July 11<sup>th</sup>, 2025

The following is a written document to respond to the comments issued by the Design Review Board of the City of Miami Beach under file number **DRB25-1115**, in regards to the new construction to be located on 900 S Shore Dr (lot 10) Miami Beach, FL 33141. Architect's answers are in **bold**:

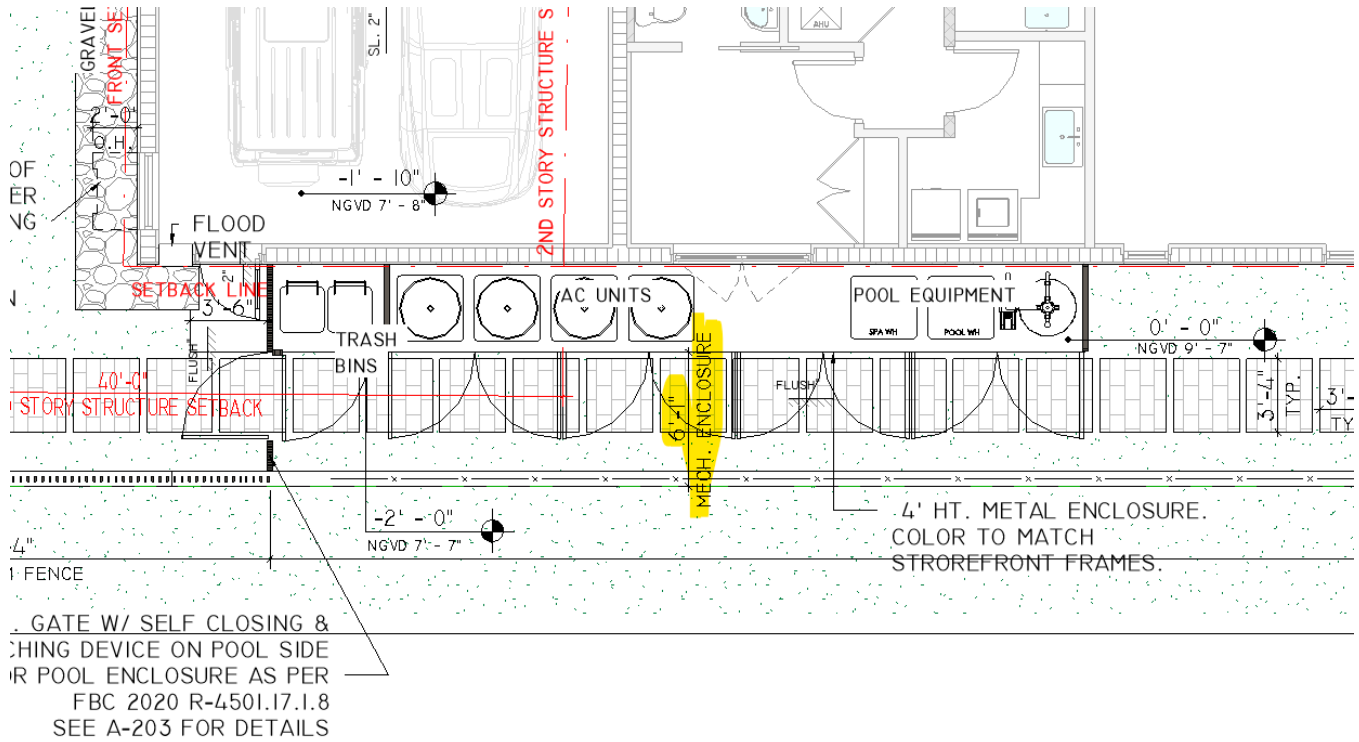
i. Elevations: for clarification, add North, West, S, E to the elevation title blocks.

**R= Noted, please see the updated titles in sheets A-200 and A-201.**

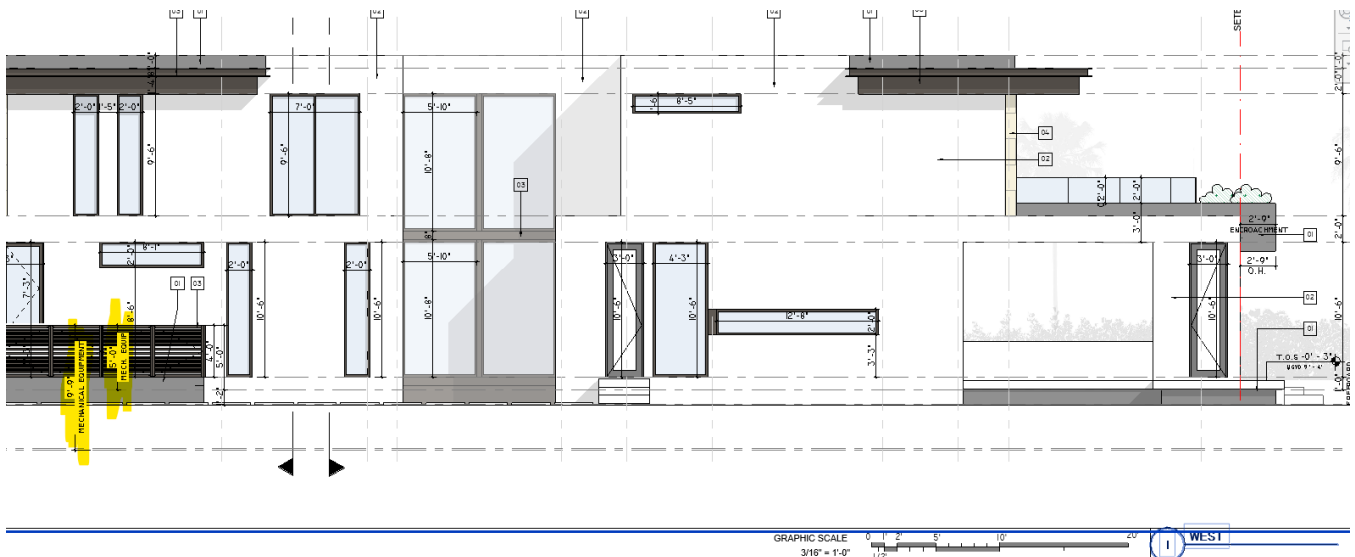
b. The maximum height of the equipment, including attached screening elements, shall not exceed 5 feet above current flood elevation, with a maximum height not to exceed 10 feet above grade, as defined in section 1.2.1, of the lot on which it is located.

Provide the height of the mechanical and pool equipment measured from the highest point of the equipment to BFE and grade, not to exceed the height requirement.

R= See the West elevation in sheet A-201 for the mechanical and pool equipment's and enclosure height both from the BFE and the Grade elevations. In both cases, the code is being met.

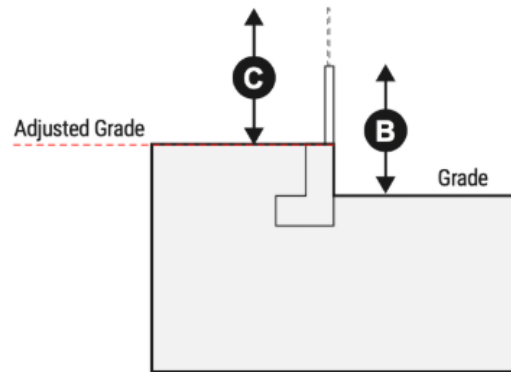
c. Site plan: Retaining walls/fences located at the rear yard shall be lowered to 5 FT, provide height from grade. If is an existing wall higher than this, provide building permit that approve such wall or the wall needs to be lowered.

**R= Noted. Per the updated survey, please note that the existing wall to remain is 5ft in height.**

**Additionally, the rear yard fence has been lowered to 5' from future adjusted grade, following code section 7.2.2.3.b.12.H:**

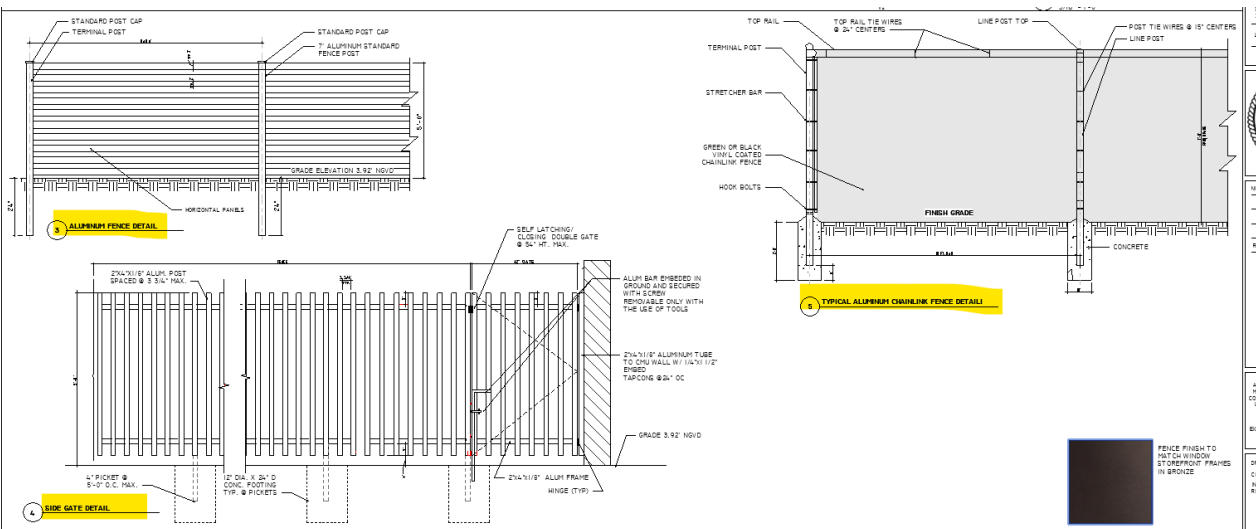
d. Site plan/first floor plan: Retaining walls/fences: Demonstrate compliance with Section 7.2.2.3.b.12.H. Provide height and setbacks if applicable for the existing/proposed walls on the required rear, side, side facing the street and front yard on the site plan. indicate where the new and existing walls stop/start. Provide separate detailed elevations for the proposed walls/fences/gates, provide height dimensions from grade, materials etc.,

**R= Please see sheets A-100, A-202 and A-203 for the fences details.**

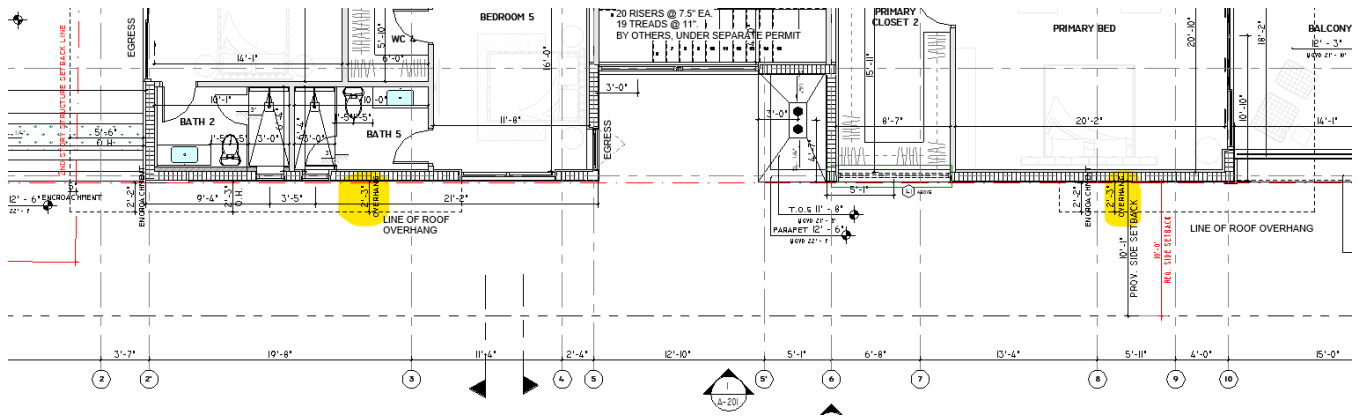
g. Projections: Portion of the roof overhang on the west side is projecting more than 25% of the required setback. Revise and provide dimension.

**R=** Please note that the overhangs were updated. Refer to sheet A-102 and A-103.

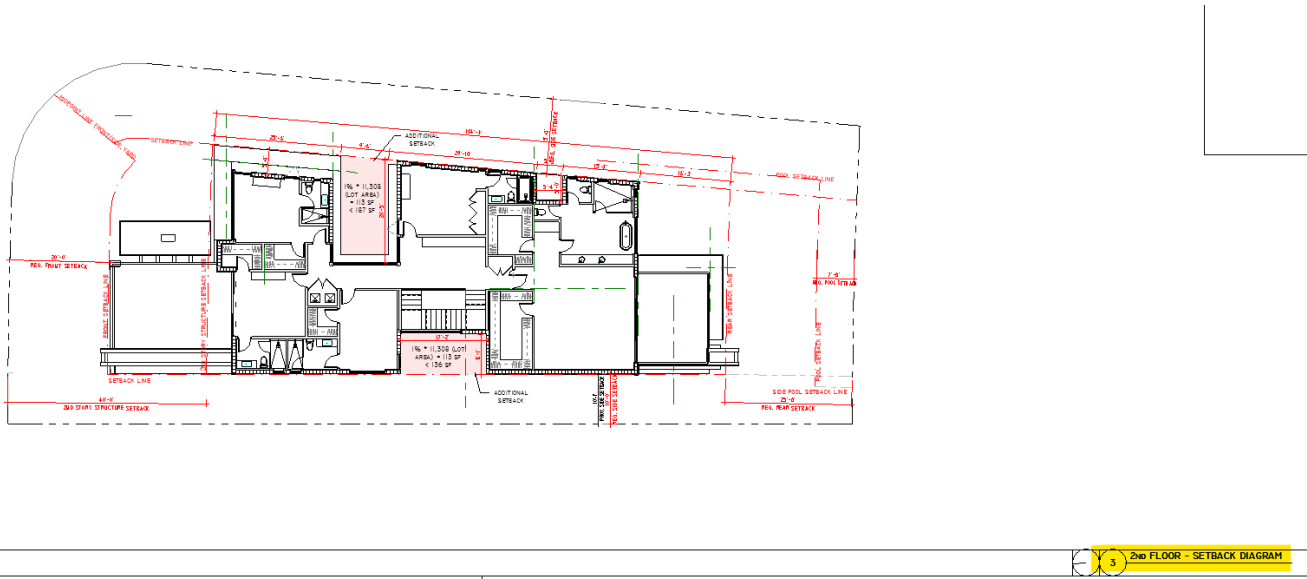
in depth, measured perpendicular from the minimum required side setback line. The square footage of the additional open space shall not be less than one percent (1%) of the lot area. Provide plan diagrams for both sides with width, depth and required/provided areas and calculations related to the lot area. as presented the East side is not in compliance, there is an overhang going parallel to the setback line over this space, this needs to be removed.

**R= We have updated the additional open spaces, please refer to the Setback Diagram in sheet A-100.2B.**

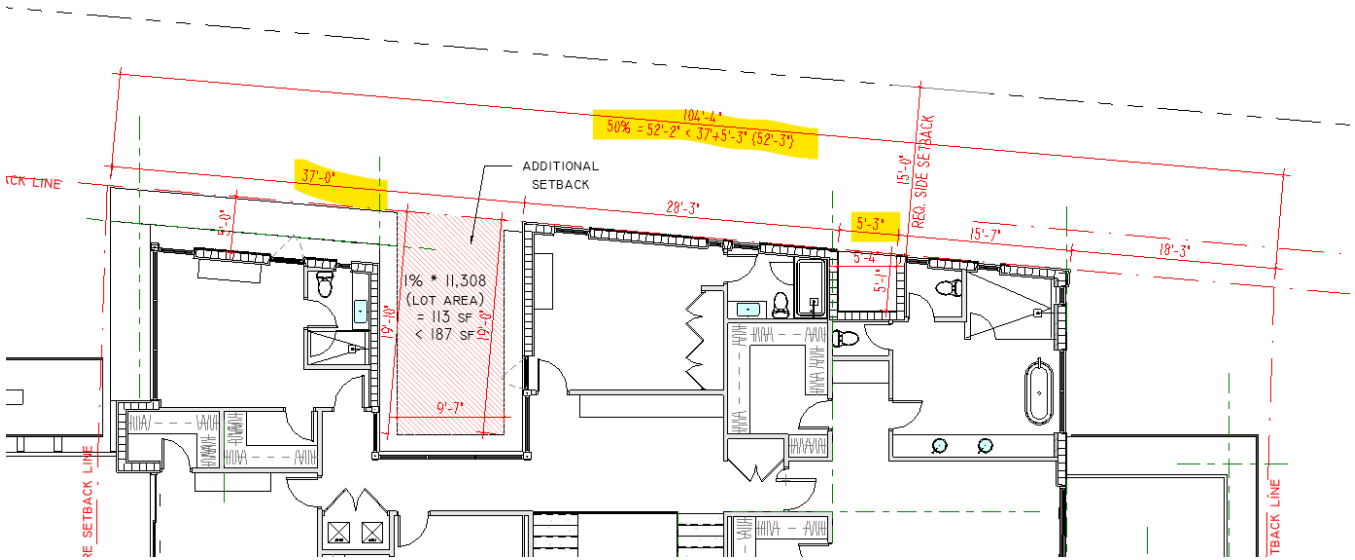
k. The project is not in compliance with section 7.2.2.3.b.2.B: At least 50 percent (50%) of the second floor along a side elevation facing a street shall be set back a minimum of 5 feet from the minimum required setback. Revise and Provide calculations, total and overall dimensions of the second floor side elevations, and revise the elevation that needs to be setback 5 FT (provide setback dimension).

**R= Please see sheet A-100.2B to verify compliance.**

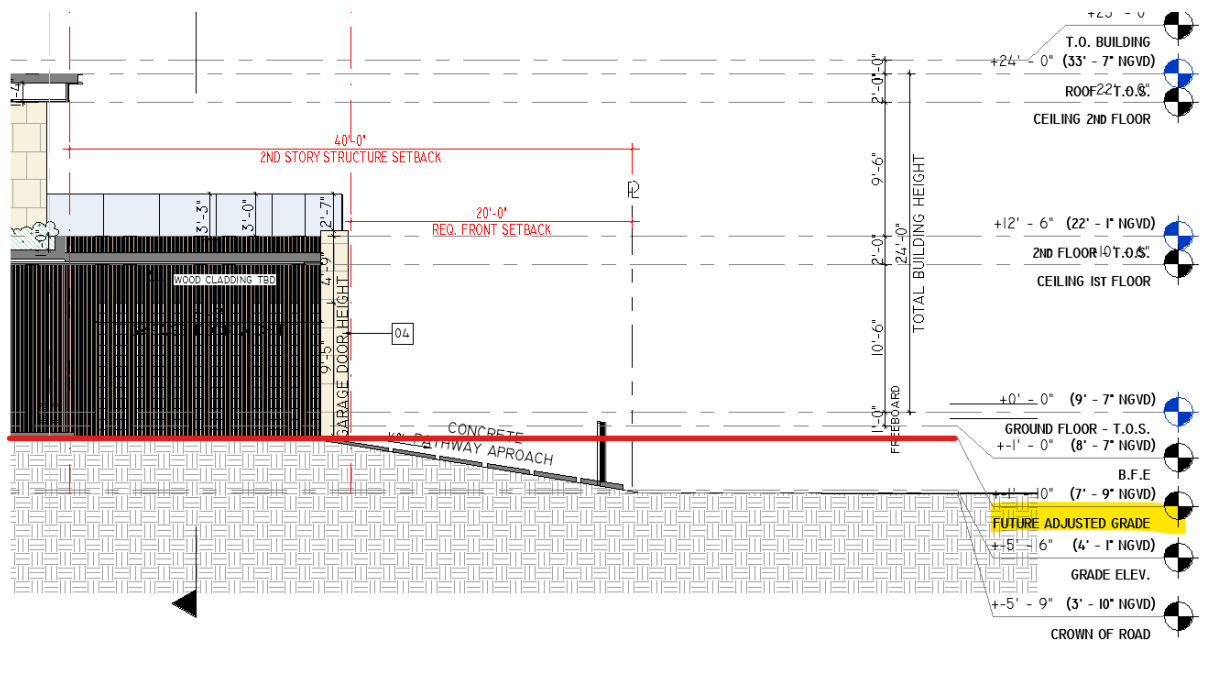
l. The minimum yard elevation is future adjusted grade. Future adjusted grade means the midpoint elevation between the future crown of the road and the base flood elevation plus minimum freeboard for a lot or lots. Provide written confirmation from the Public Works Department that identifies the future crown of the road for further review of compliance the minimum yard elevation.

**R= Please see attached the email from public works where the Future Crown of Road was specified. The yard elevation is the future adjusted grade.**
